Service Letter No. 66

FAA:
Rev. B: MAY 18 2006

SUBJECT: *Attach bolts for spring gear and trigear models*

Detail -1

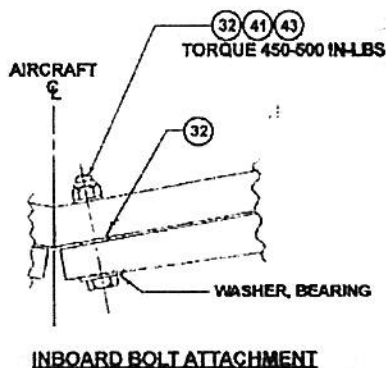
1) Install the following per **Detail -1:**

Note: Apply LPS 3 (Rust inhibitor, Heavy Duty) liberally during assembly of inboard bolt attachment – to bolt holes and washer surfaces – to bolts, nuts and washers – also applies to outboard attachment and axle assembly attachment.

Note: Retorque bolts after 25 hours and per Maintenance Manual thereafter.

Detail -2

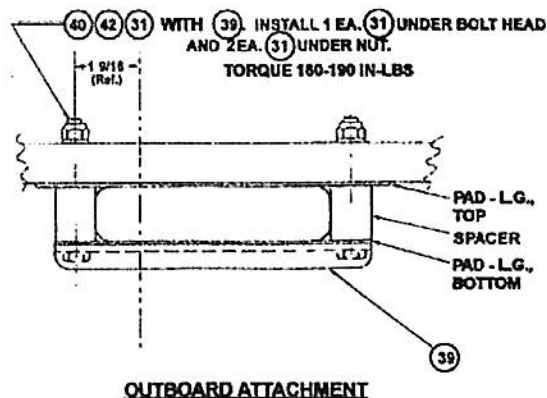
2) Install the following per **Detail -2:**

Note: The maximum combined height of washers that should be used is 1/8 inch and should have at least one thread of the bolt protruding through the nut.
